# **Safety Recall N58 / NHTSA 13V-483**

## **Reprogram Instrument Cluster & ABS**

### **Module / Alternator Ground Wire**

2014 (WK) Jeep® Grand Cherokee

**Figure 1 – Alternator Ground Wire Location**

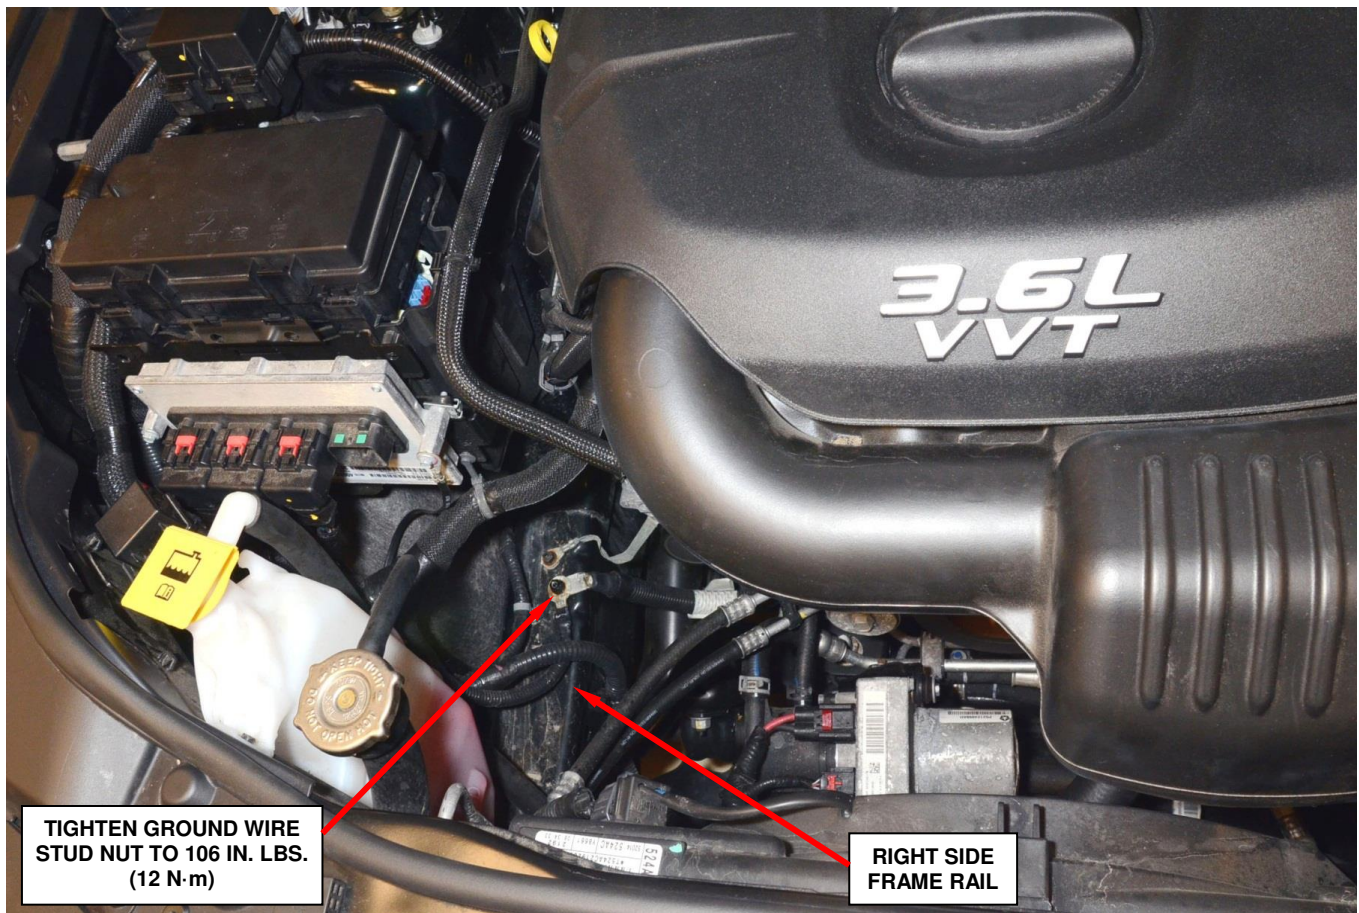
The instrument cluster and the ABS module must be reprogrammed. The alternator ground wire, at the right frame rail, must also be tightened.

1. Open the hood.
2. Locate the ground wire stud nut on top of the right frame rail (Figure 1).
3. Using a torque wrench and 10 mm socket, tighten the ground wire stud nut to 106 in. lbs. (12 N·m).
4. Continue with **Section B. – Reprogram Instrument Cluster & ABS Module.**
